**Consolidated Statements from Opponents of
the 2nd Story Project at 985 Channing Avenue, Palo Alto**

The plans were received on 08/24/20 for review by Planning Staff. Based on the initial feedback from staff, the application **cannot be deemed complete at this time**. A revised set of plans incorporating the following information and requirements must be submitted for review:

DUNLAP RESIDENCE

985 CHANNING AVENUE
PALO ALTO, CA 94301

DATE 03 AUGUST 2020

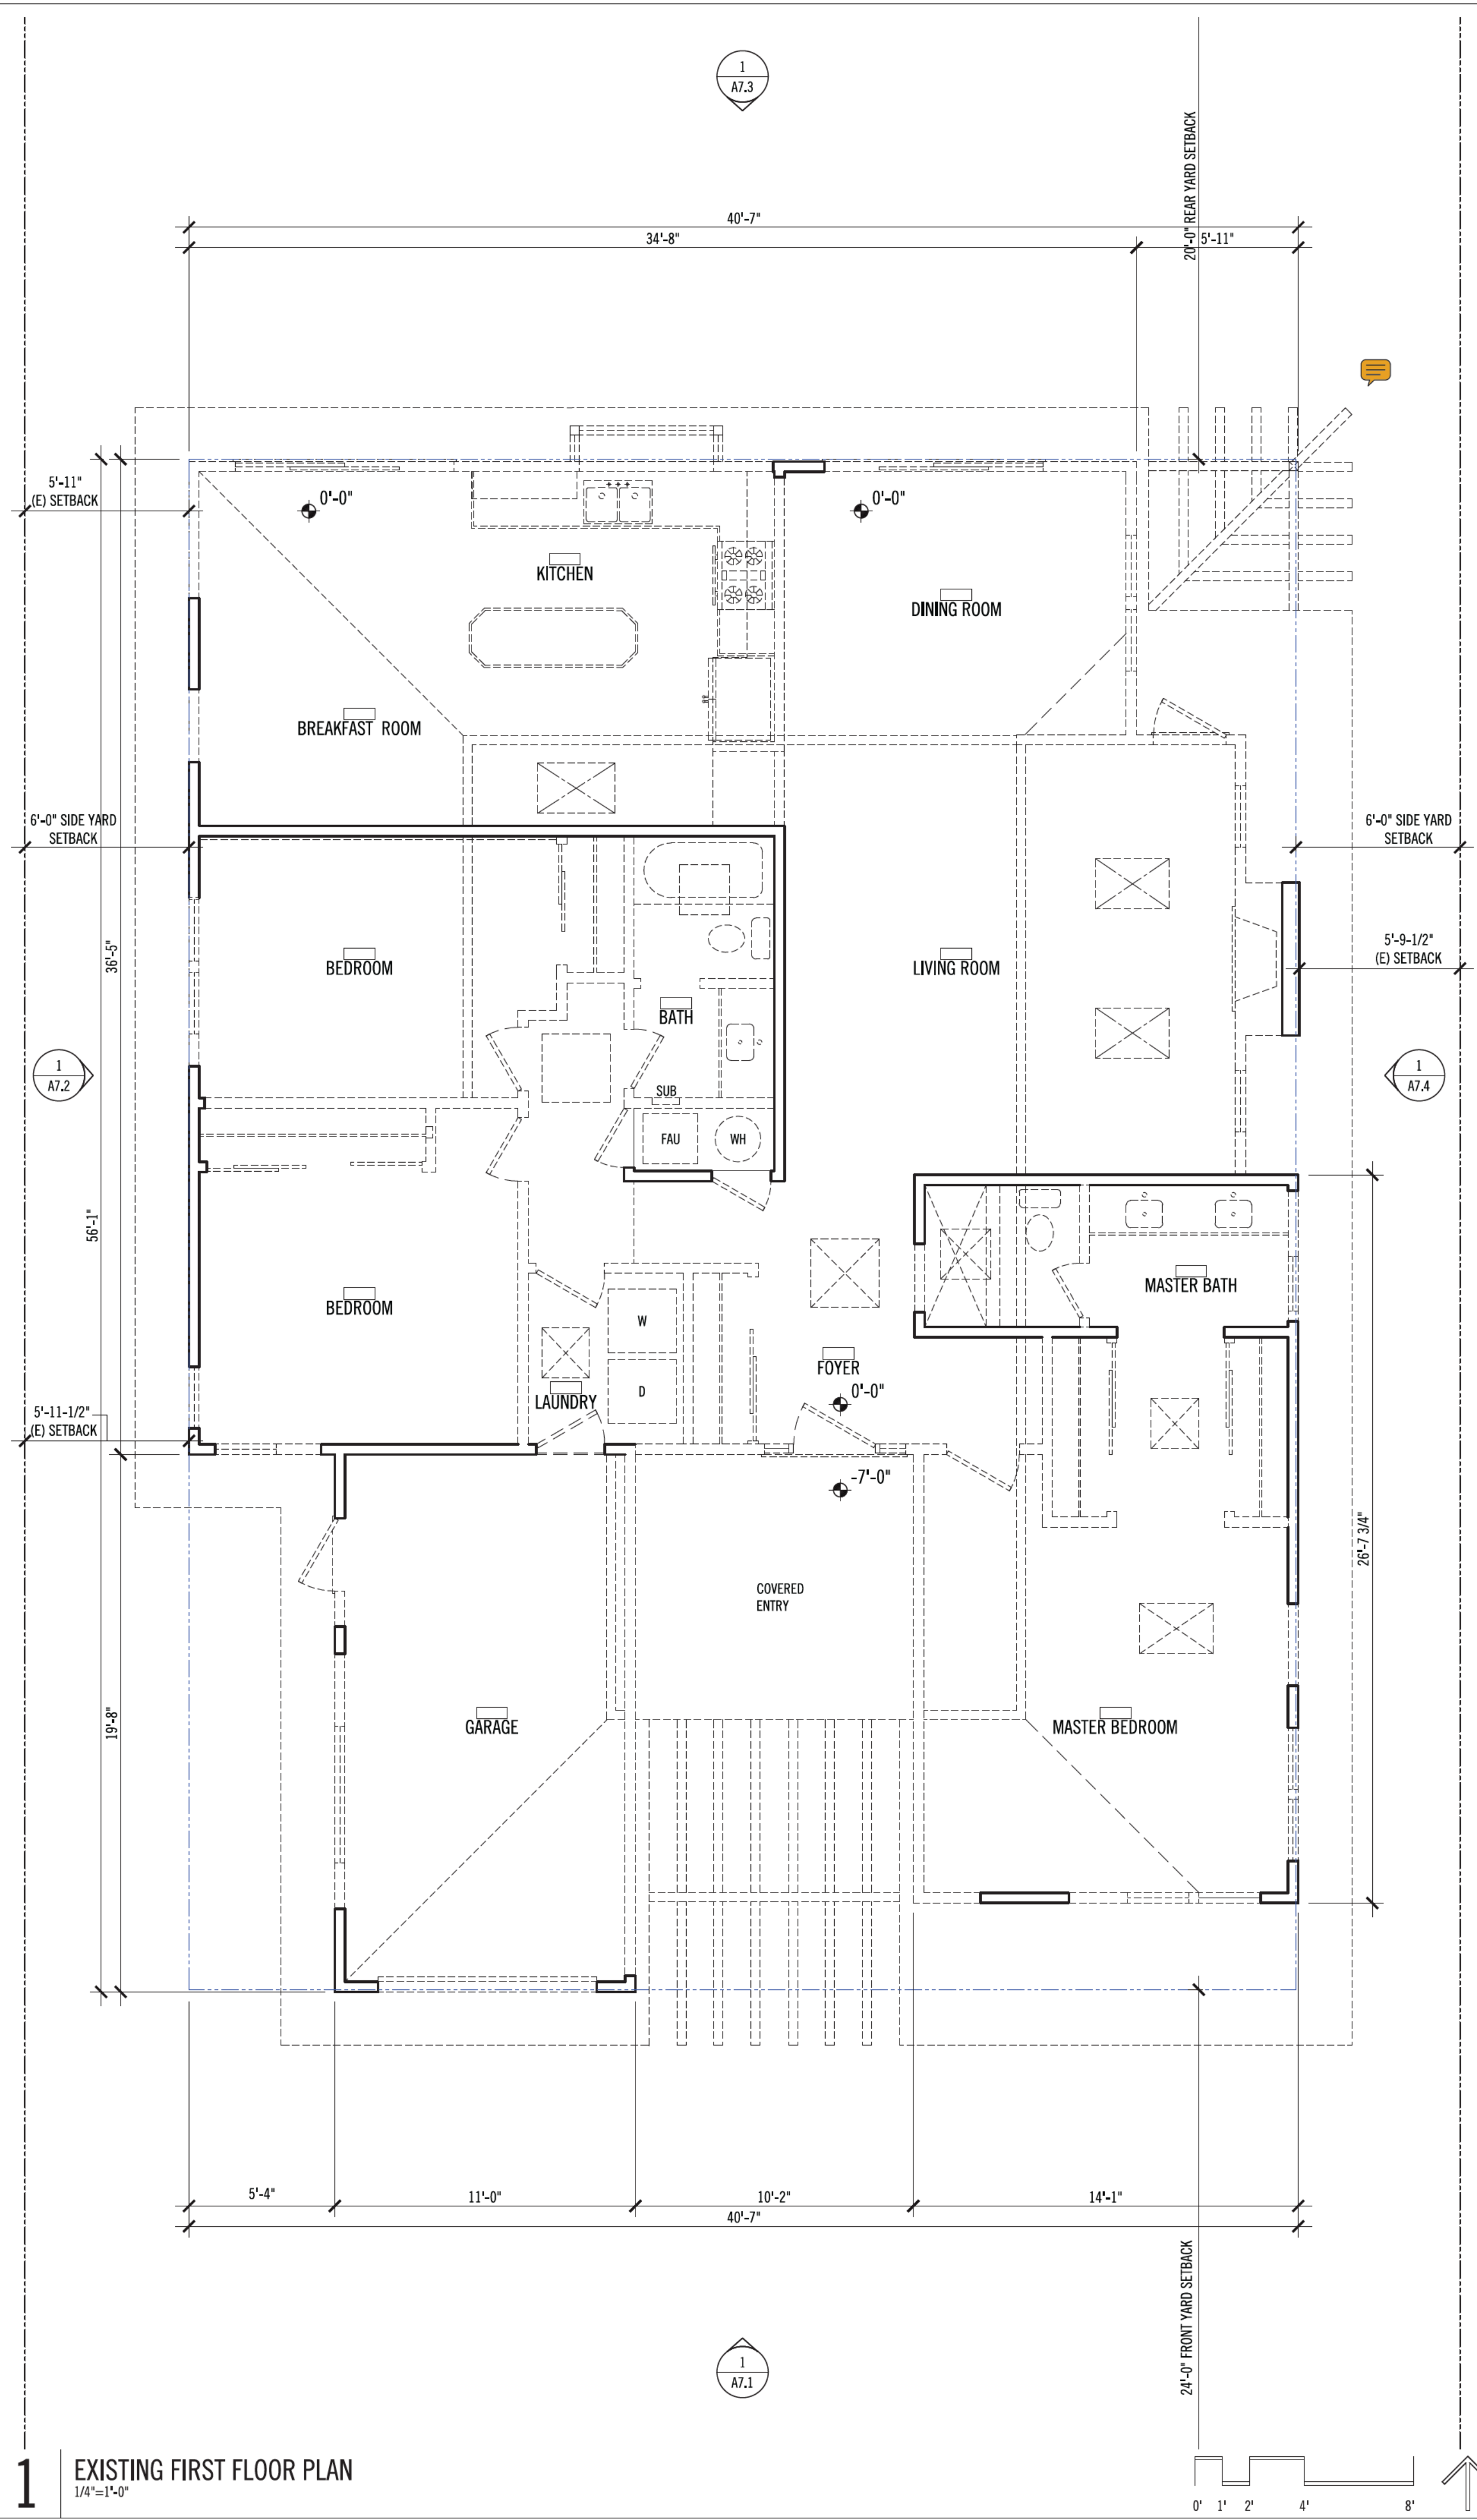
INCOMPLETE: Update plans to include mechanical equipment to be used. Provide spec sheet and decibel rating of new unit.

Any uncovered parking provided that is adjacent to a wall must provide an additional .5' of clearance space for door swing. Update the plans to provide this information.

Note driveway material

Update to show

IR-2: To meet guideline one and five, revise the site plan to provide landscape, such as medium sized screening trees or tall screening shrubs within side yards between this home and adjacent homes. Where existing landscape exists fill gaps in the landscape. Landscape can also be used to mitigate privacy, but it cannot be the primary means of privacy mitigation where direct sight lines exist to neighboring property. Provide plant choices with botanical names and quantities; indicate 24-inch box size and 8-foot minimum installed height for trees and 15-gallon size and 8-foot minimum installed height for screening shrubs.

EXISTING & PROPOSED EXTERIOR ELEVATIONS - WEST

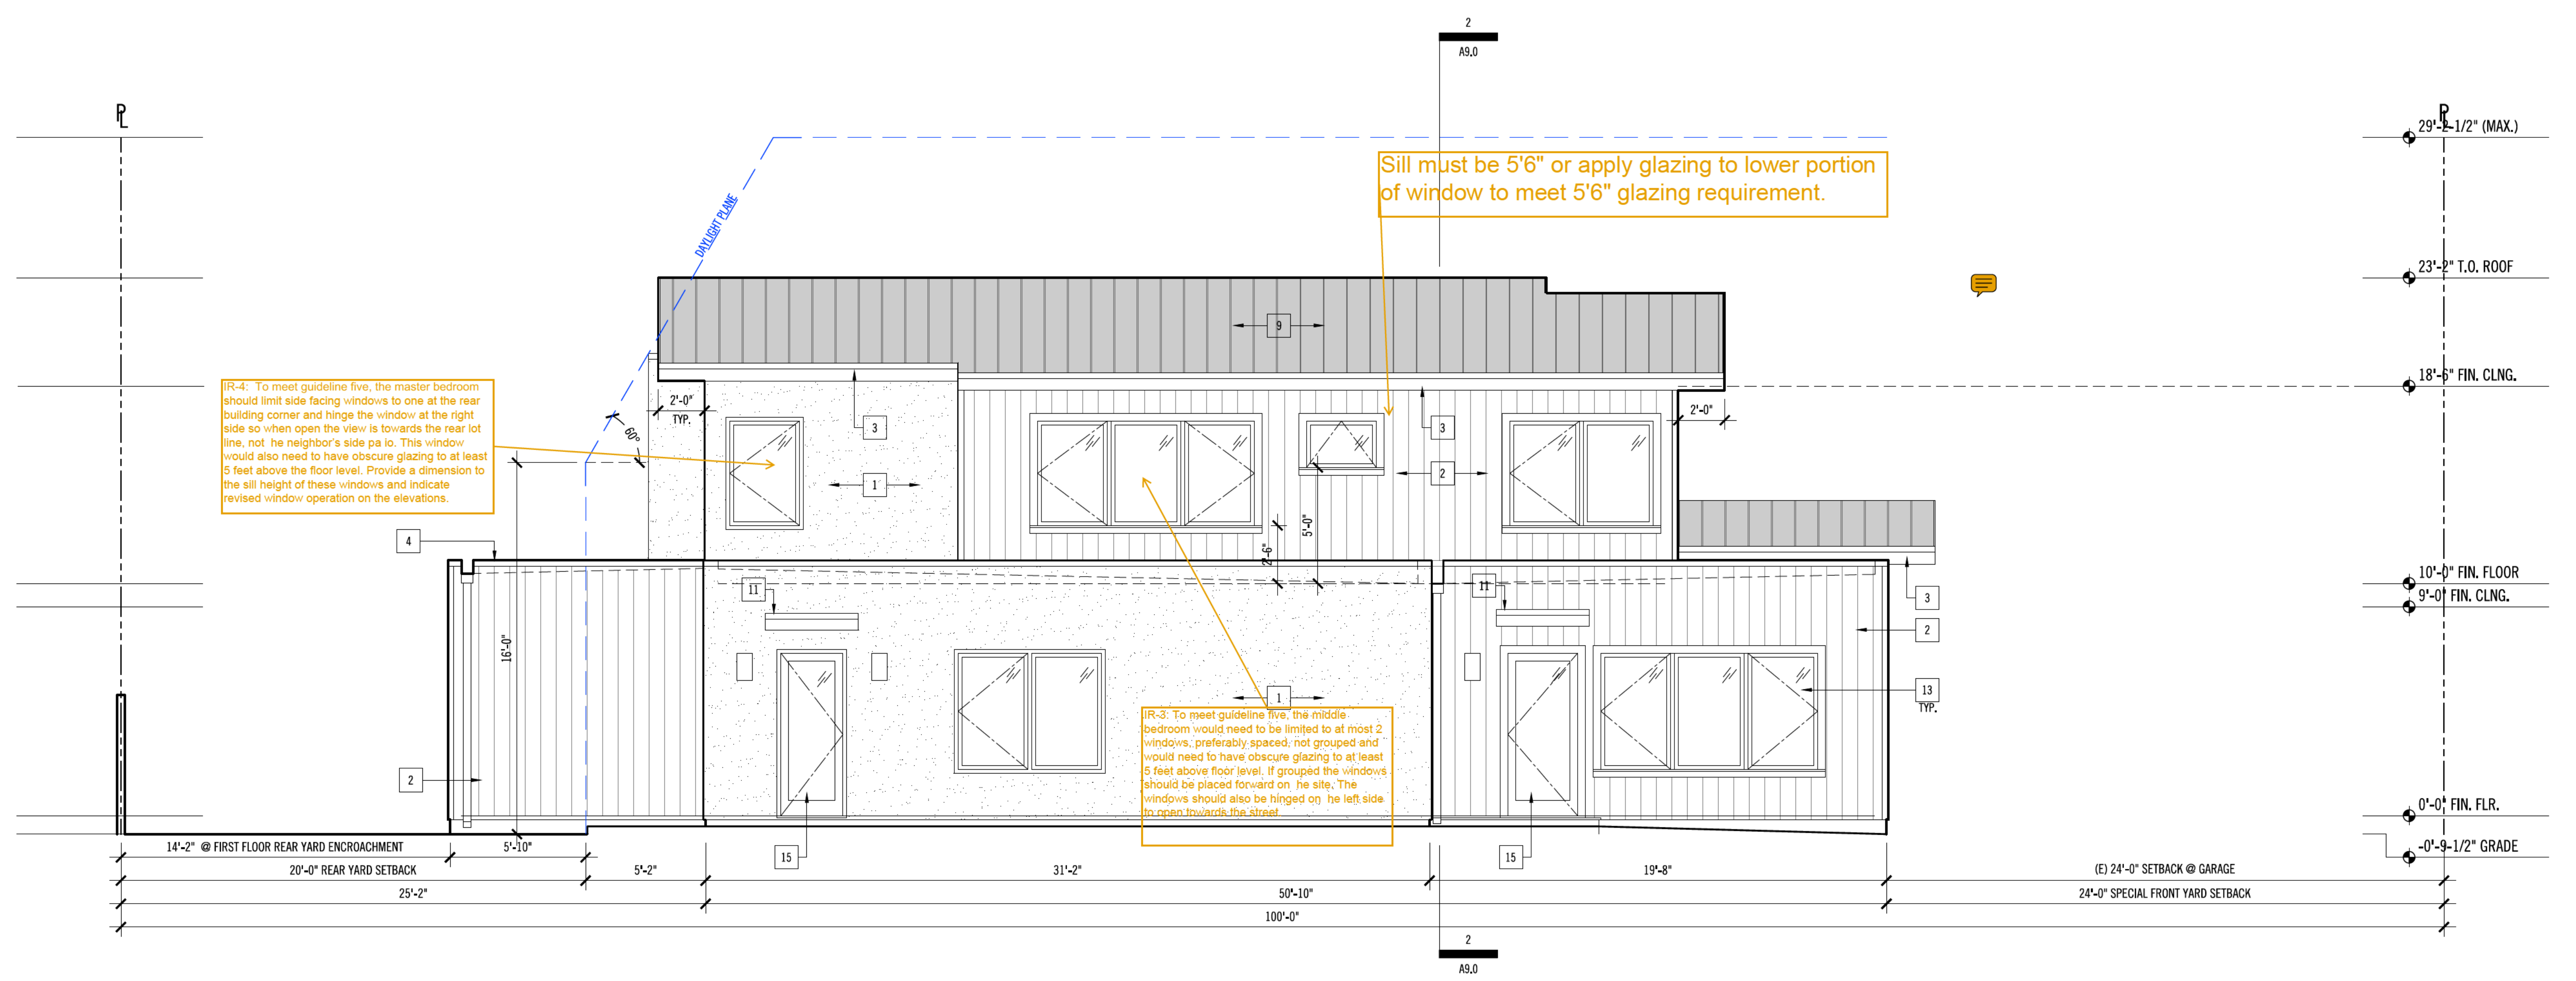
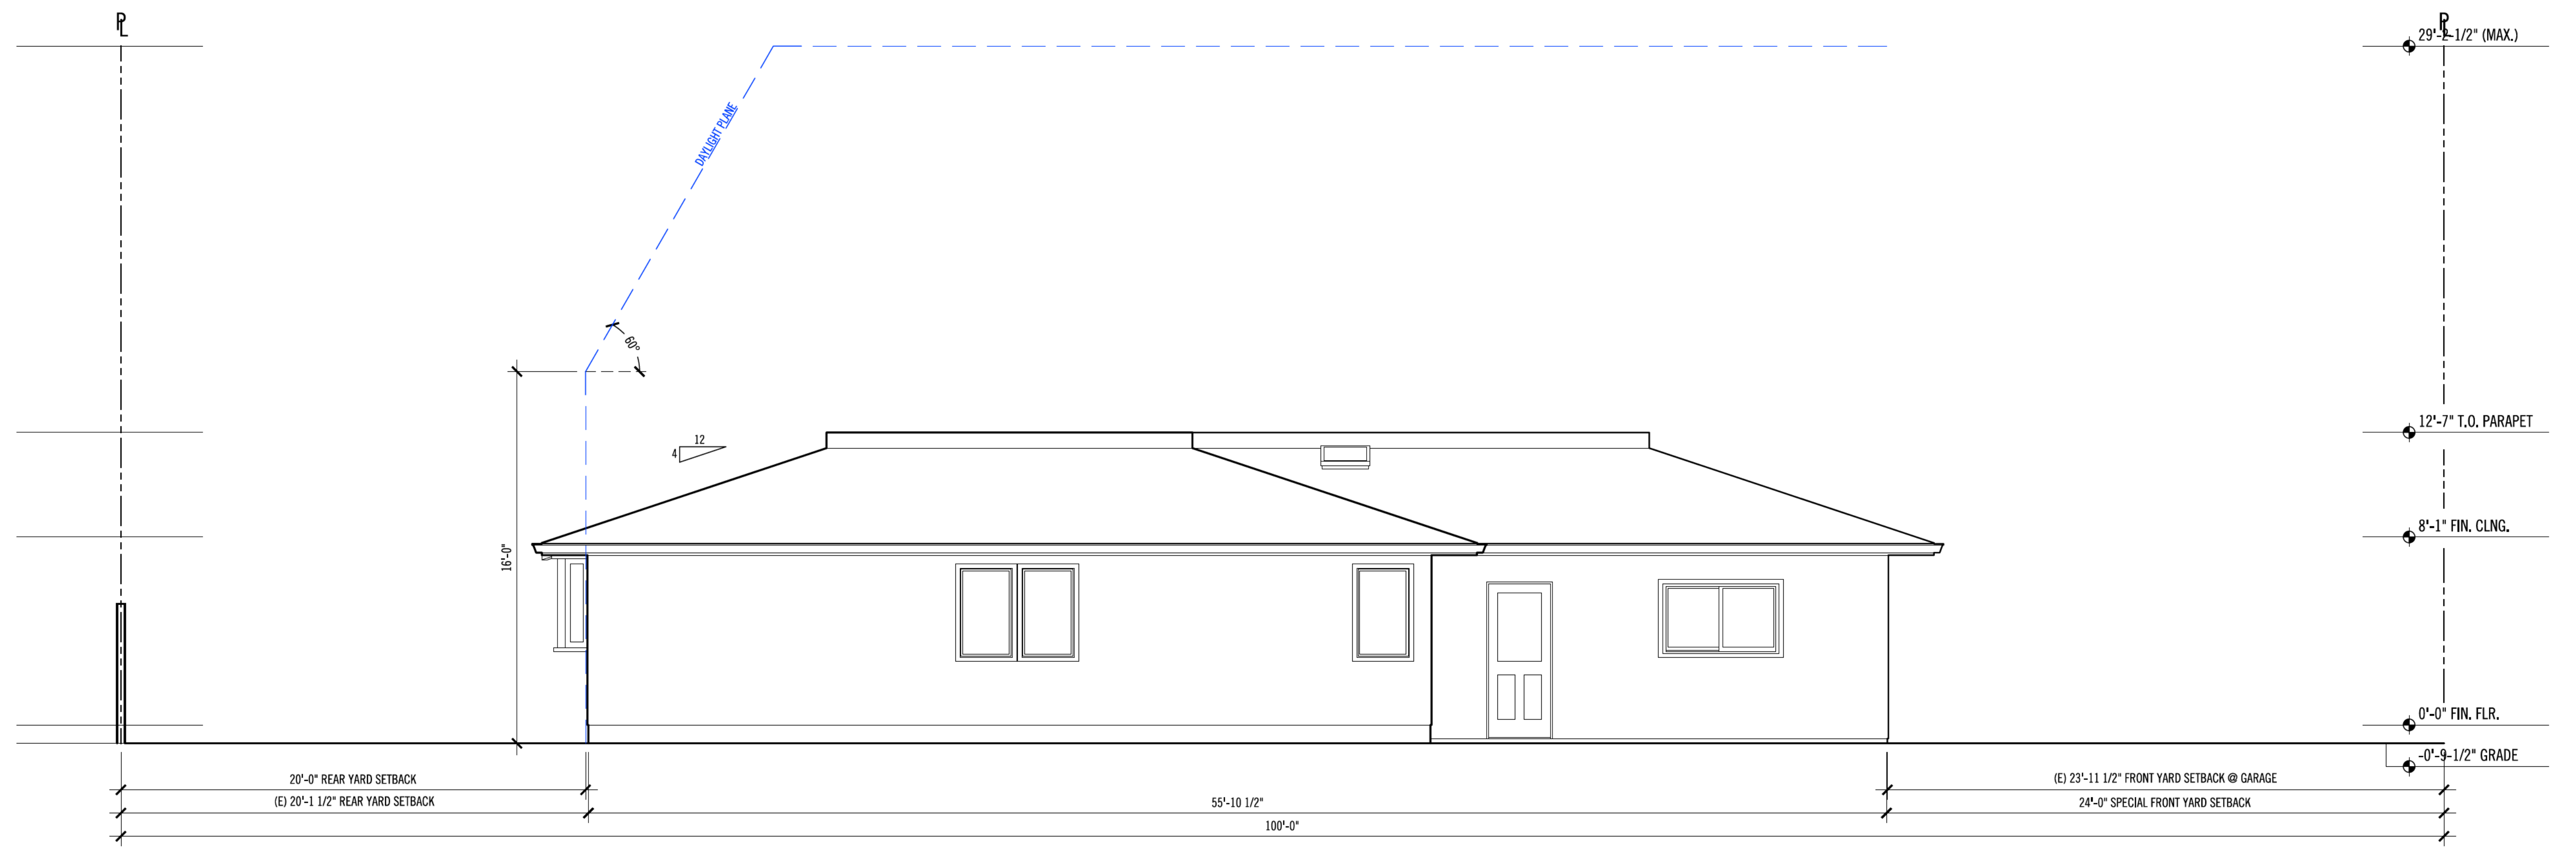
A7.2	Callout	Garrett Sauls : Planning	Sill must be 5'6" or apply glazing to lower portion of window to meet 5'6" glazing requirement.

Page Reference	Annotation Type	Reviewer : Department	Review Comments
A7.2	Comment	Garrett Sauls : Planning	Windows along this side of the building must utilize obscured glazing in order to comply with the IR Guidelines. This glazing cannot be a film applied to the window and must be applied to a minimum of 5'6" from the finished floor. Update the plans to include this information.
A8.0	Callout	Garrett Sauls : Planning	Clarify outline of drawing to identify top of roof and bottom of roof slope.
A1.0	Comment	Arnold Mammarella : Planning IR	<p>Individual Review Guidelines General Information:</p> <p>The Single-Family Individual Review process and the applicability of these guidelines were established by PAMC 18.12.110 to preserve the character of Palo Alto neighborhoods by placing specific requirements related to streetscape, massing, and privacy for new two-story homes and upper story additions.</p> <p>There are five Individual Review Guidelines: 1. Site planning for driveway, garage and house, 2. Neighborhood compatibility for height, mass, and scale, 3. Resolution of architectural form, massing, and rooflines, 4. Visual character of street facing facades and entries, and 5. Privacy from second floor windows and decks.</p> <p>For approval, a proposal needs to be consistent with all five guidelines. The review considers the proposal's response to each guideline's approval criterion statement including whether the "key points" associated with each guideline have been followed. Guideline illustrations are also used to inform determinations in the evaluation. Please see the City's illustrated guideline booklet for more information about these regulations.</p> <p>Individual Review Evaluation Comments:</p> <p>Review determinations and comments relate to plans filed August 31, 2020 for a whole house renovation with a new second story addition to an existing one-story house. The existing attached garage would be converted to space within a new attached ADU.</p> <p>Review comments may reference specific changes or clarifications needed to meet the guidelines, including those shown on specific plan sheets. No neighbor comments were available at the time of this review. Note: Evaluation for zoning compliance is provided separately.</p> <p>G1 — Site Planning: Placement of Driveway, Garage, and House</p> <p>Approval Criterion: The driveway, garage, and house shall be placed and configured to reinforce the neighborhood's existing site patterns (i.e. Building footprint, configuration and location, setbacks, and yard areas) and the garage and driveway shall be subordinate to the house, landscaping and pedestrian entry as seen from the street.</p> <p>[Guideline Key Points: 1. Minimize the driveway's presence and paving; 2. Locate the garage to be subordinate to the house; 3. Configure the house footprint to fit the neighborhood pattern; 4. Create landscaped open spaces between homes; 5. Locate the upper floor back from the front facade and/or away from side lot lines when next to one-story homes; and 6. Do not place the second floor so that it emphasizes the garage.]</p> <p>Comments: The property is a 52.5' wide by 99.6' deep interior lot on the north side of Channing Avenue one lot in from Lincoln Avenue. It abuts a similarly sized corner lot 991 Channing Avenue with a tall one-story house on its right (east) side, 975 Channing Avenue, a narrow deep interior lot with a stepped mass and fairly low two-story</p>

Page Reference	Annotation Type	Reviewer : Department	Review Comments
A7.2	Callout	Arnold Mammarella : Planning IR	IR-3: To meet guideline five, the middle bedroom would need to be limited to at most 2 windows, preferably spaced, not grouped and would need to have obscure glazing to at least 5 feet above floor level. If grouped the windows should be placed forward on the site. The windows should also be hinged on the left side to open towards the street.
A7.2	Callout	Arnold Mammarella : Planning IR	IR-4: To meet guideline five, the master bedroom should limit side facing windows to one at the rear building corner and hinge the window at the right side so when open the view is towards the rear lot line, not the neighbor's side patio. This window would also need to have obscure glazing to at least 5 feet above the floor level. Provide a dimension to the sill height of these windows and indicate revised window operation on the elevations.
